CLAREMONT BUSINESS PARK 2 FILING NO. 2

CONSTRUCTION PLANS

JUNE 2023

V2_Construction Drawings.pdf Markup Summary

LOT 2 - SAND FILTER POND 3 SITE PLAN SCALE 1"=6'

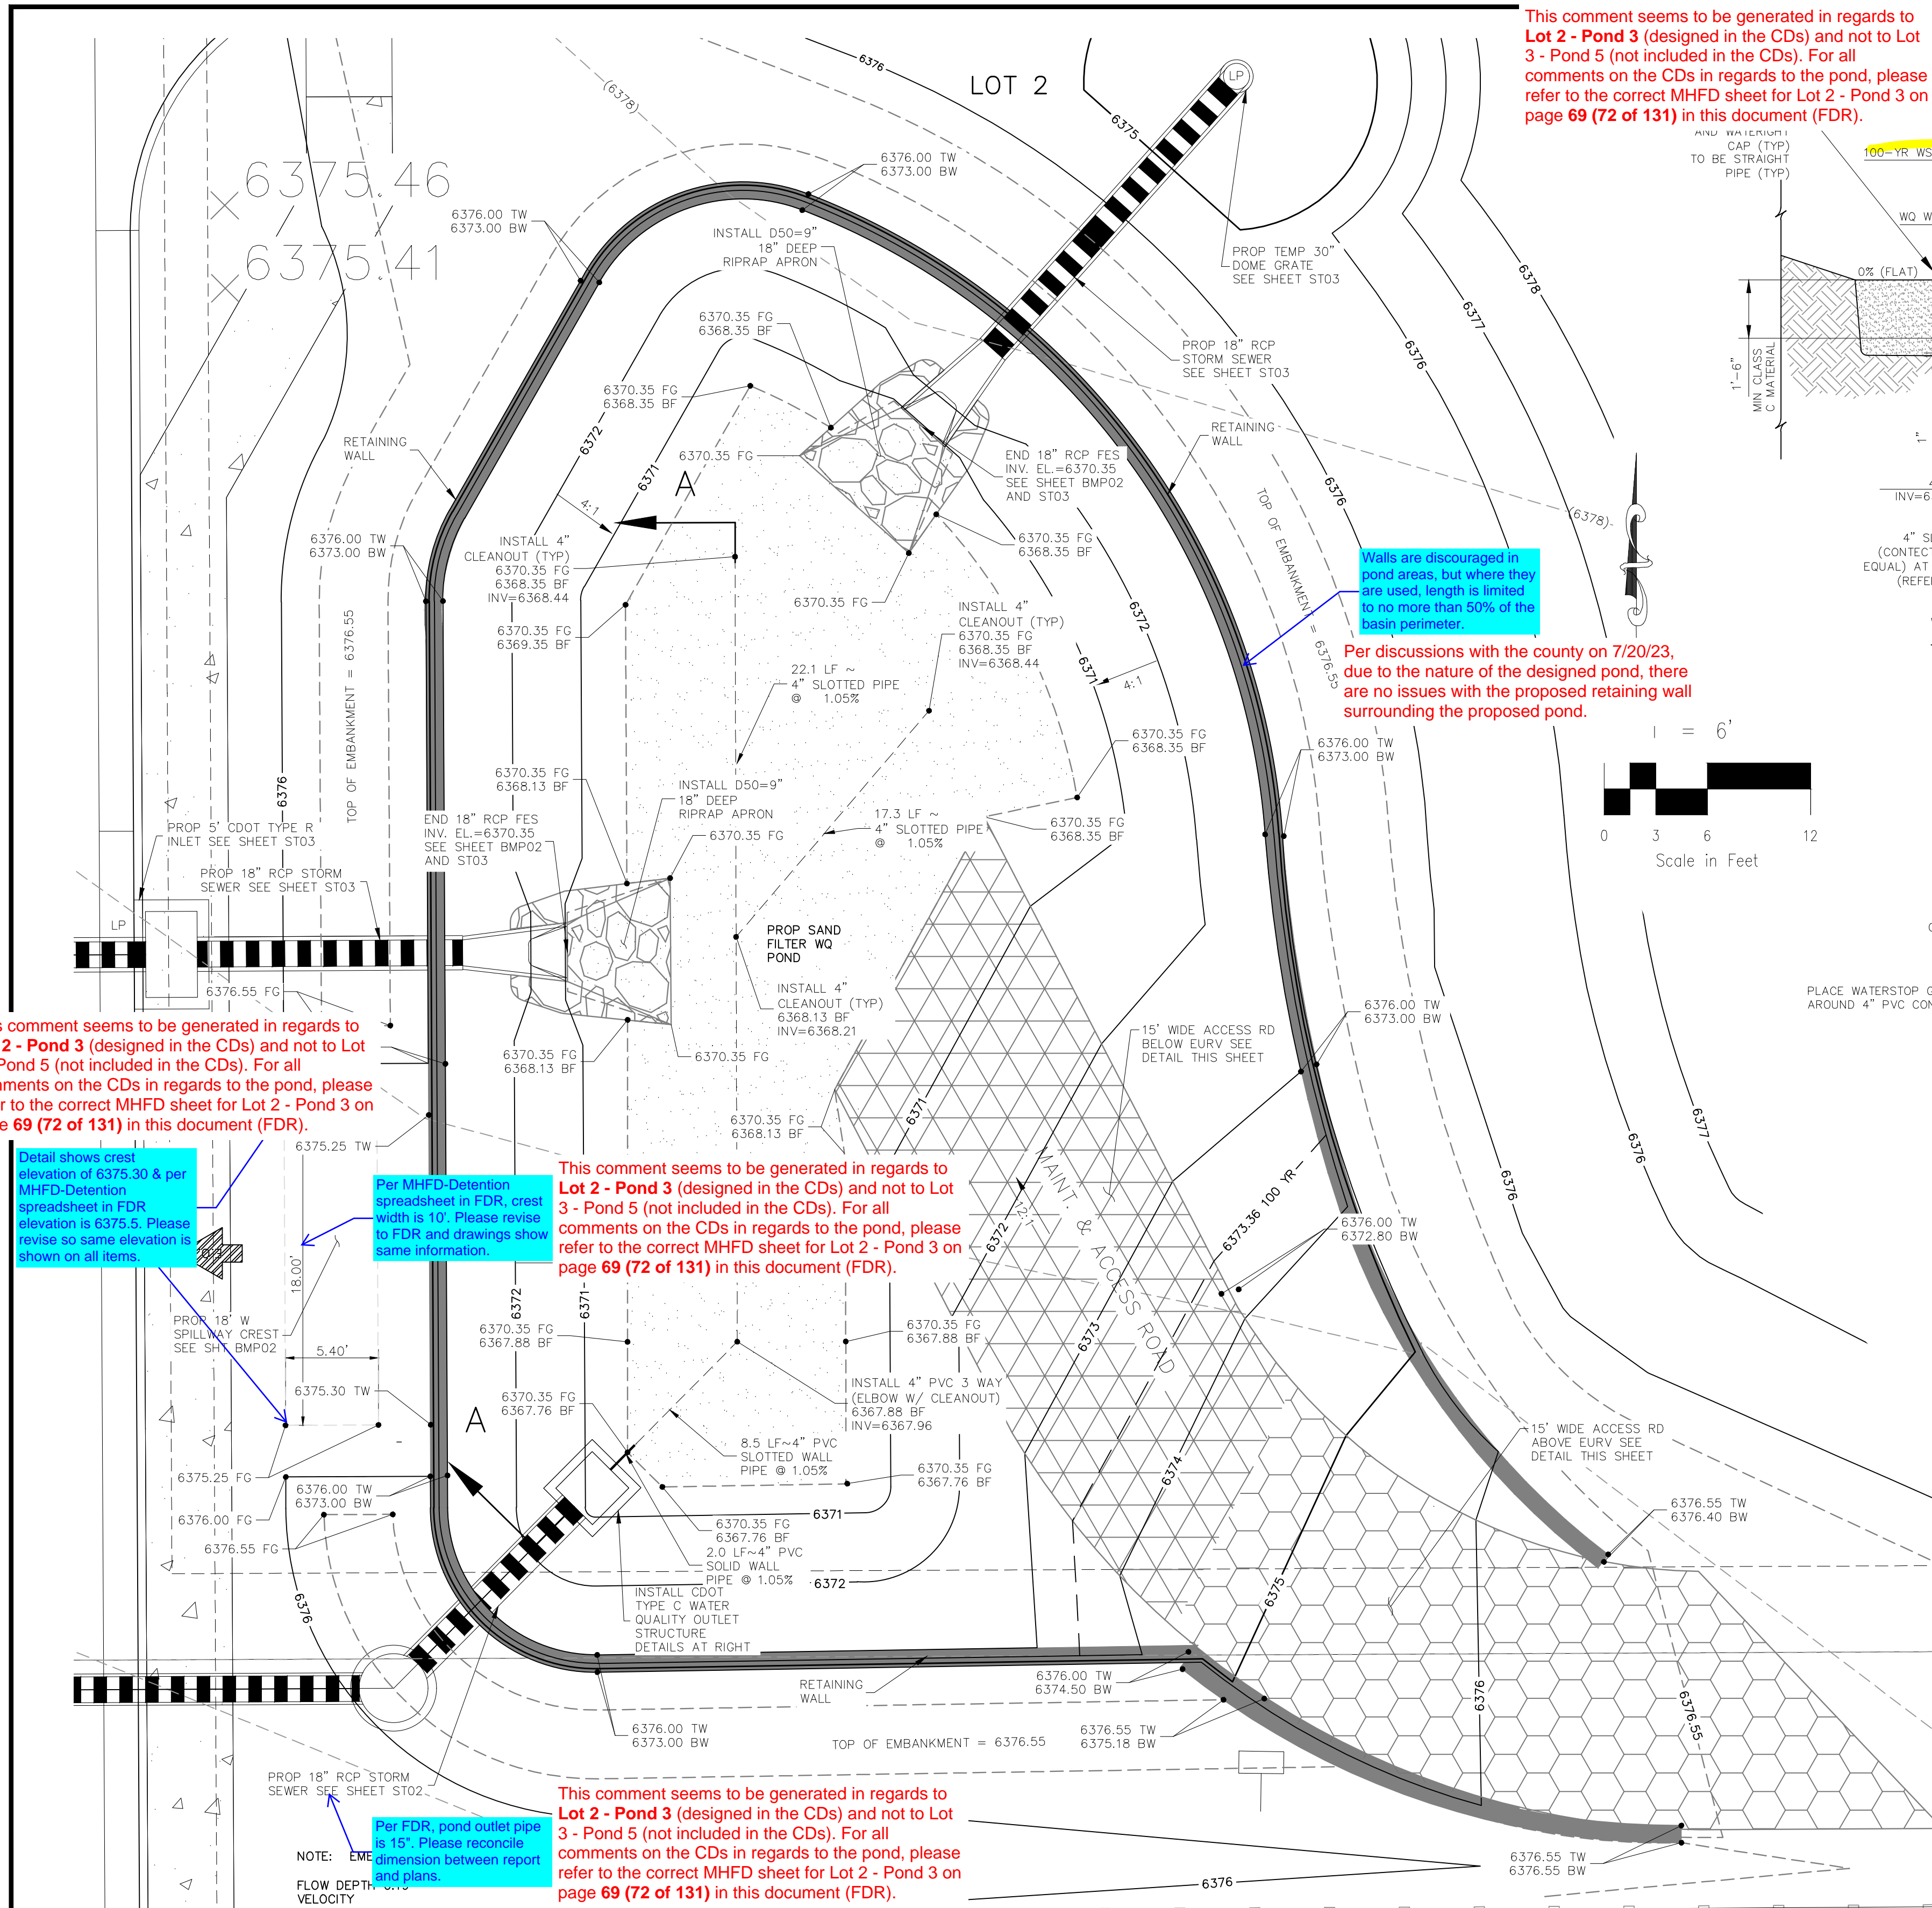
Detail shows crest elevation of 6375.30 & per MHFD-Detention spreadsheet in FDR elevation is 6375.5. Please revise so same elevation is shown on all items.

Per MHFD-Detention spreadsheet in FDR, crest width is 10'. Please revise to FDR and drawings show same information.

NOTE: Per FDR, pond outlet pipe is 15". Please reconcile dimension between report and plans.

Elevation does not match information on MHFD-Detention spreadsheet in FDR

Walls are discouraged in pond areas, but where they are used, length is limited to no more than 50% of the basin perimeter.

This comment seems to be generated in regards to Lot 2 - Pond 3 (designed in the CDs) and not to Lot 3 - Pond 5 (not included in the CDs). For all comments on the CDs in regards to the pond, please refer to the correct MHFD sheet for Lot 2 - Pond 3 on page 69 (72 of 131) in this document (FDR).

Per discussions with the county on 7/20/23, due to the nature of the designed pond, there are no issues with the proposed retaining wall surrounding the proposed pond.

UNDERDRAIN ORIFICE PLATE NOT TO SCALE

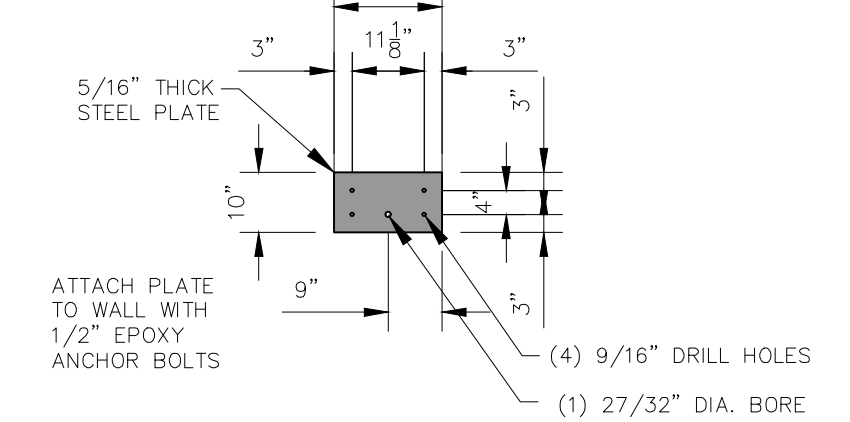
Per MHFD-Detention spreadsheet, there is no restrictor plate. Please revise so FDR and drawings have same information.

This comment seems to be generated in regards to Lot 2 - Pond 3 (designed in the CDs) and not to Lot 3 - Pond 5 (not included in the CDs). For all comments on the CDs in regards to the pond, please refer to the correct MHFD sheet for Lot 2 - Pond 3 on page 69 (72 of 131) in this document (FDR).

SPILLWAY CREST SECTION A-A
SCALE: NTS

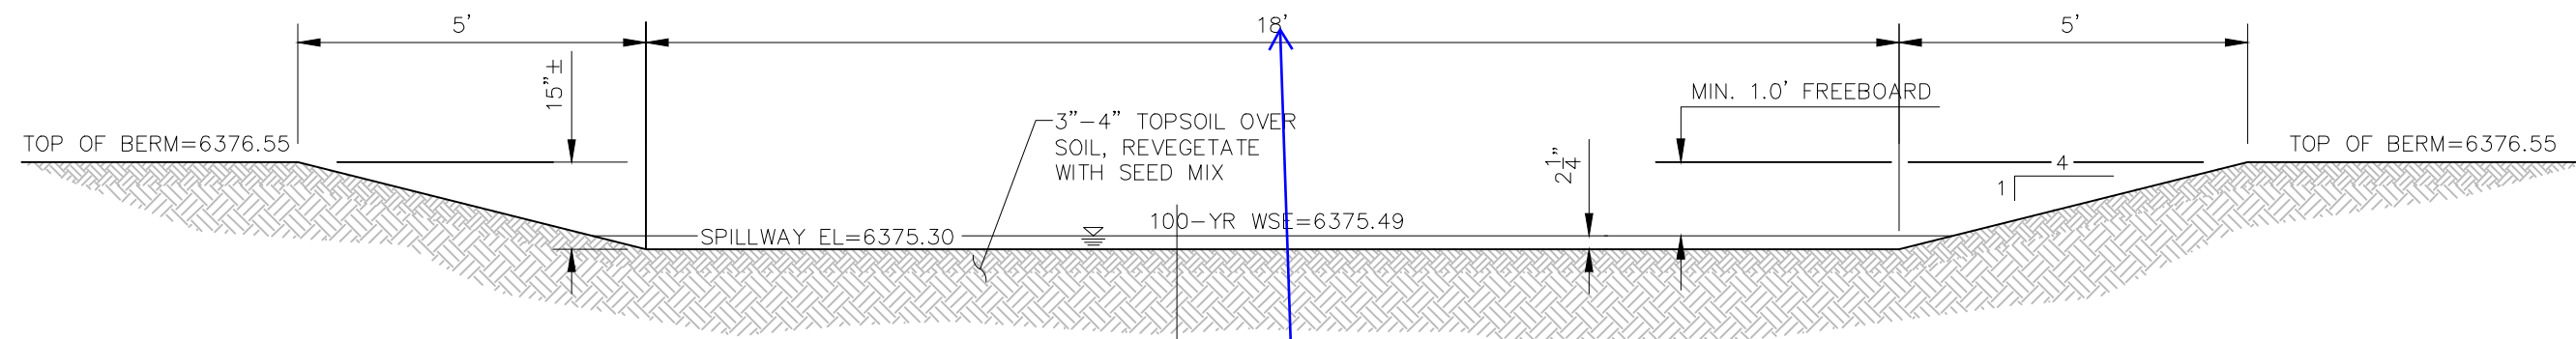
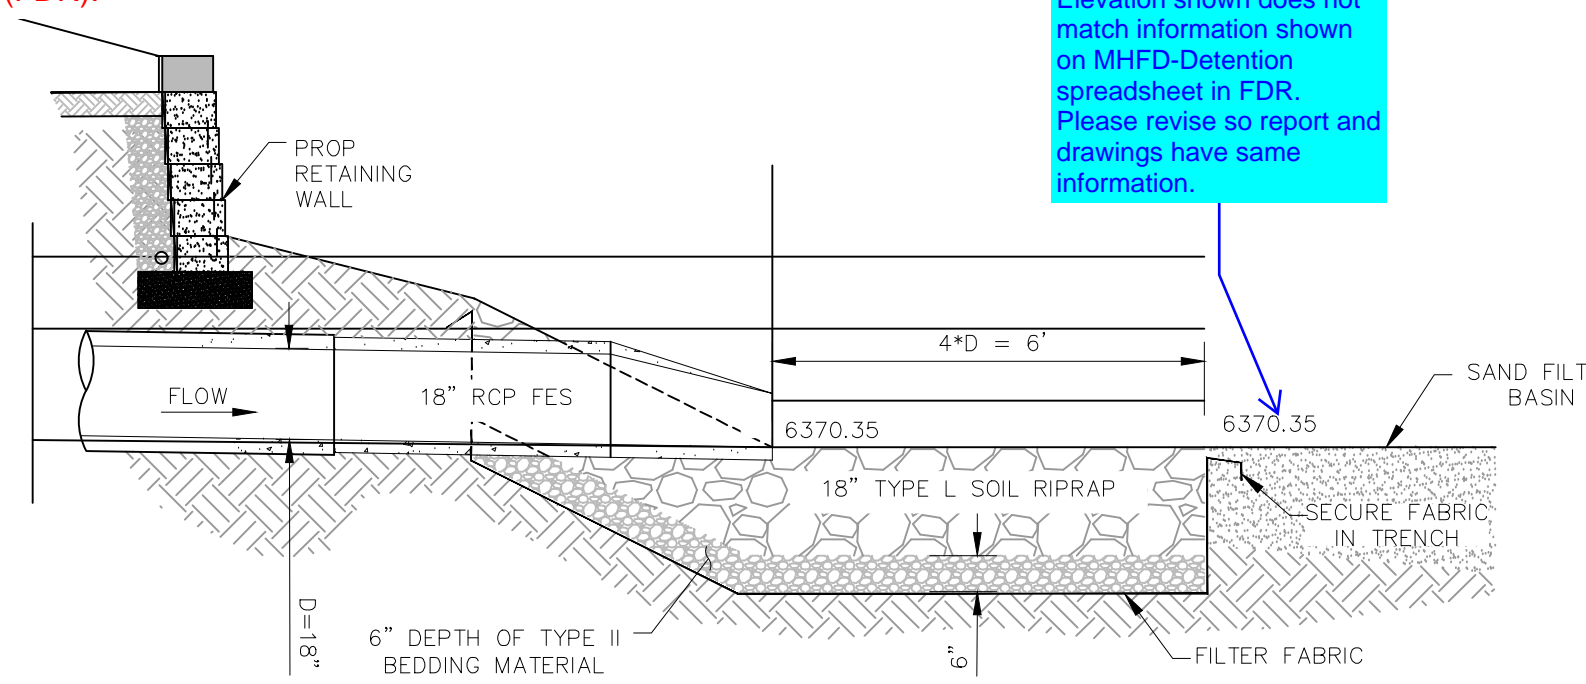
10' per mHFD-Detention spreadsheet in FDR

Elevation shown does not match information shown on MHFD-Detention spreadsheet in FDR. Please revise so report and drawings have same information.

This comment seems to be generated in regards to Lot 2 - Pond 3 (designed in the CDs) and not to Lot 3 - Pond 5 (not included in the CDs). For all comments on the CDs in regards to the pond, please refer to the correct MHFD sheet for Lot 2 - Pond 3 on page 69 (72 of 131) in this document (FDR).
